STANDARD DEPARTURE CHART-INSTRUMENT

RJFN / NYUTABARU

NIPPO SEVEN DEPARTURE

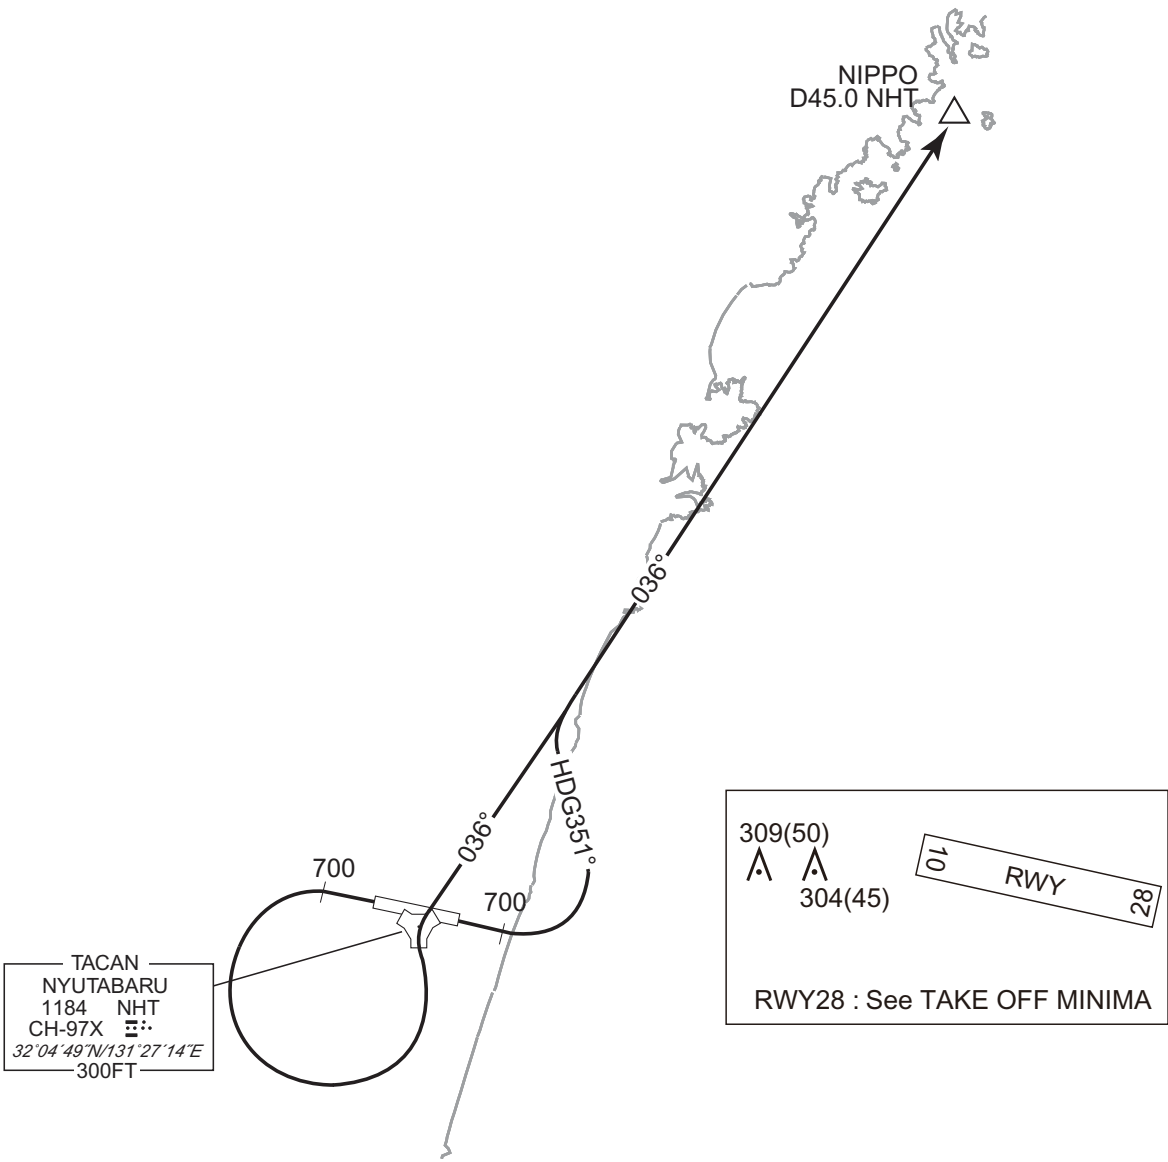
CHANGE : PROC renamed(NIPPO SEVEN DEPARTURE). PROC course(NIPPO SEVEN DEPARTURE). YATOJI TWO DEPARTURE abolished.
Restriction. Note, OBST added.

RWY10 : Climb RWY HDG to 700FT, turn left HDG 351°...

RWY28 : Climb RWY HDG to 700FT, turn left...

...to intercept and proceed via NHT R036 to NIPPO.

Note RWY28 : 5.0% climb gradient required up to 4000FT.

SAITO ONE DEPARTURE

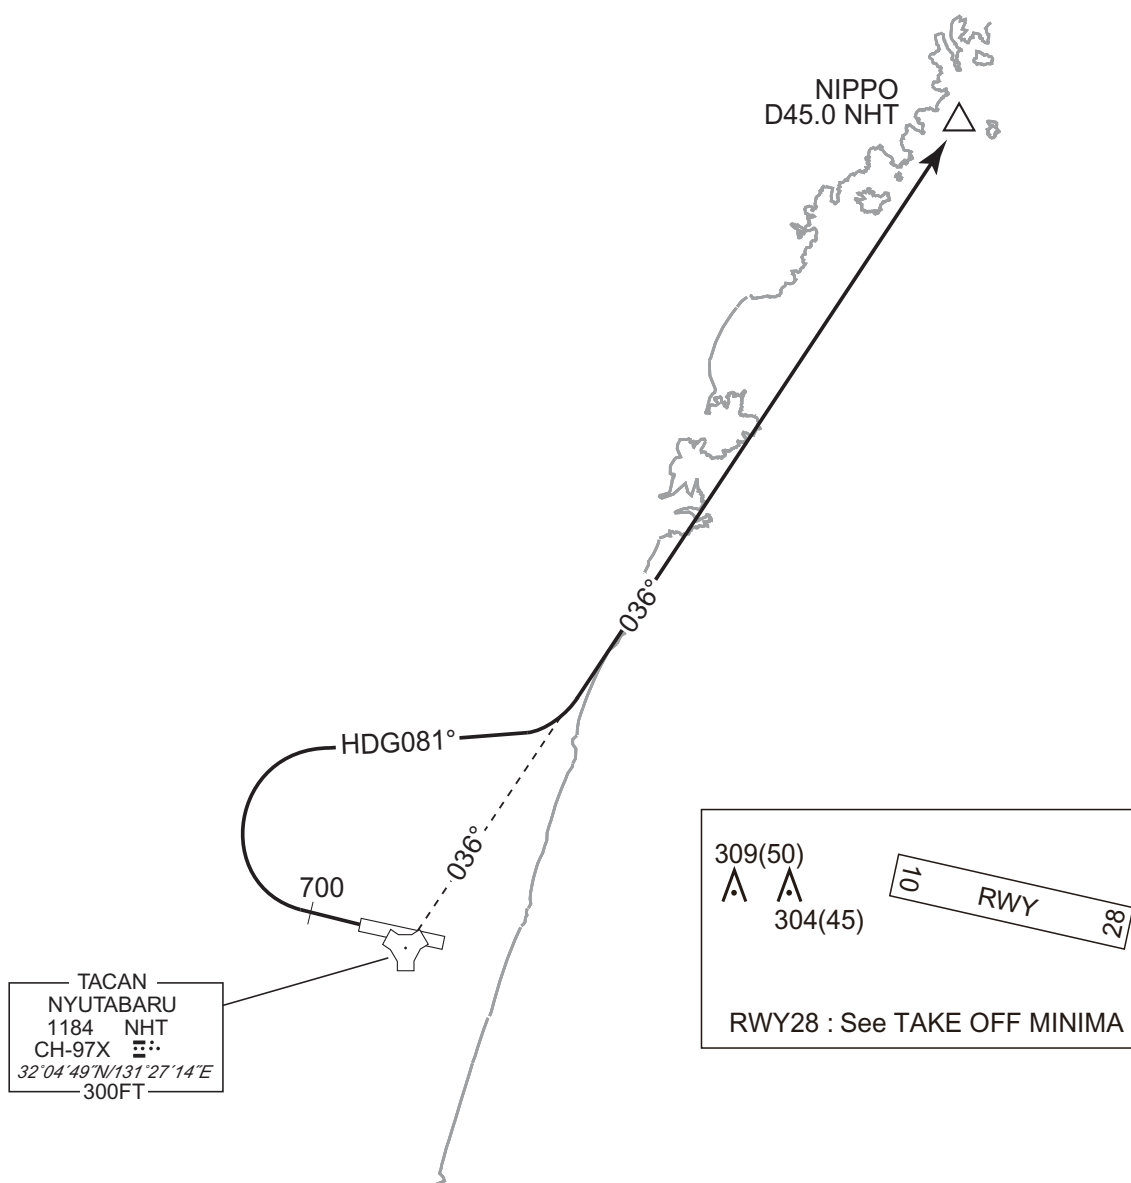
CHANGE : New PROC.

RWY28 : Climb RWY HDG to 700FT, turn right HDG 081° to intercept and proceed via NHT R036 to NIPPO.

Note RWY28 : 5.0% climb gradient required up to 4000FT.

OBST ALT 1871FT located at 6.3NM 334° FM end of RWY28.

TENSO ARRIVAL

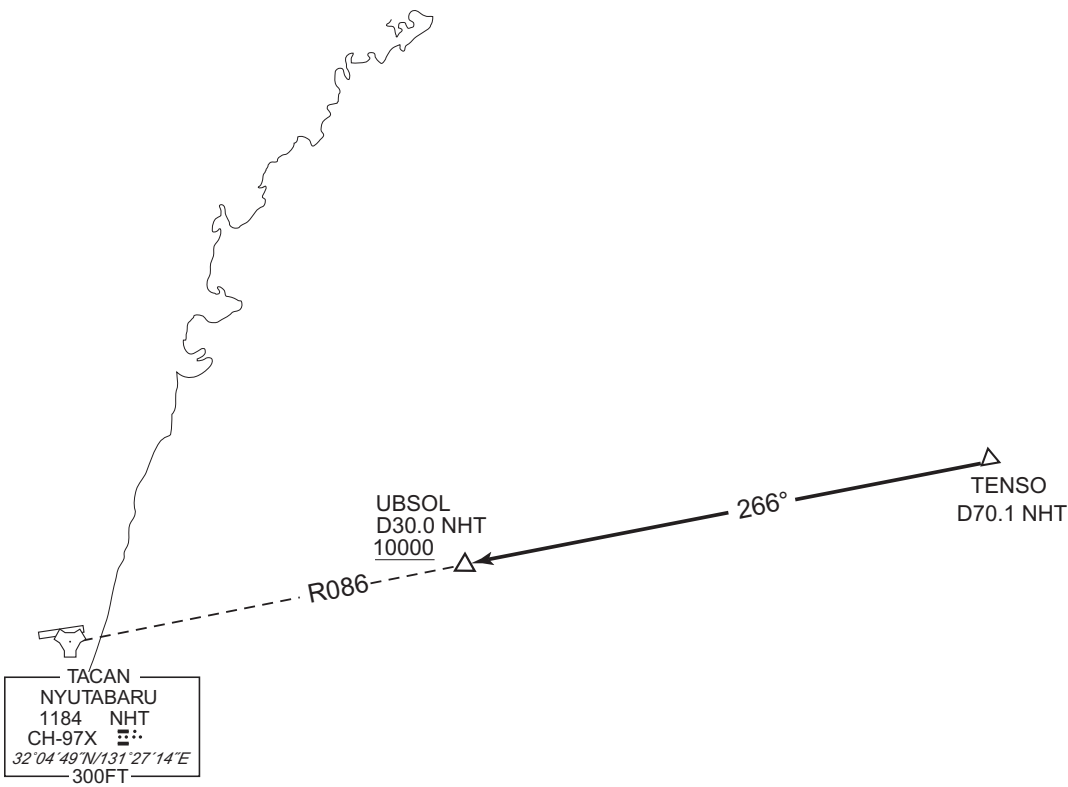
CHANGE : PROC course. UBSOL established. ALT restriction.

From over TENSO, via NHT R086 to UBSOL.
Cross UBSOL at or above 10000FT.

TACAN Z RWY28

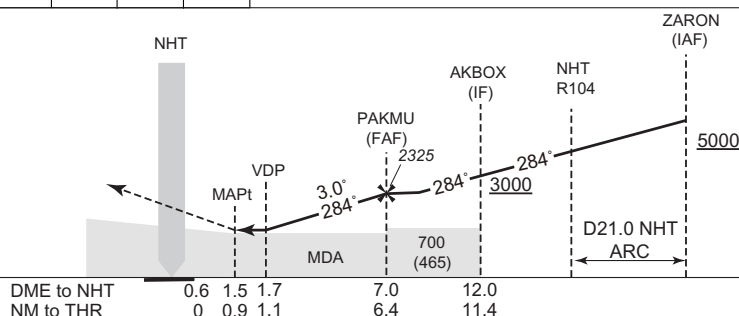
CHANGE : PROC course. Missed APCH course. MINIMA. PAKMU,AKBOX established. NM to THR. ALT(3.0°APCH Path), DME to NHT added. Missed APCH climb gradient MNM added. VAR.

Climb to 700FT on HDG 284°,
turn right HDG 111° to intercept
and proceed via NHT R066 to
ZARON and hold at 5000FT.
Contact KAGOSHIMA APP.

Missed APCH climb gradient MNM 3.0%

ILS Y or LOC Y RWY28

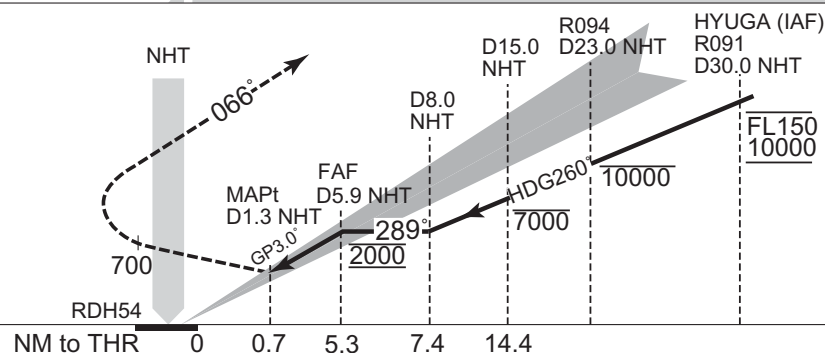
CHANGE : VAR. PROC renamed. EQPT REQUIRED added. PROC course. MISSED APPROACH course. MSA.
NM to THR added. MDA(H) for CIRCLING.

Climb to 700FT, turn right
climb via NHT TACAN R066 to
ZARON to 5000FT and hold.
Contact KAGOSHIMA APP.
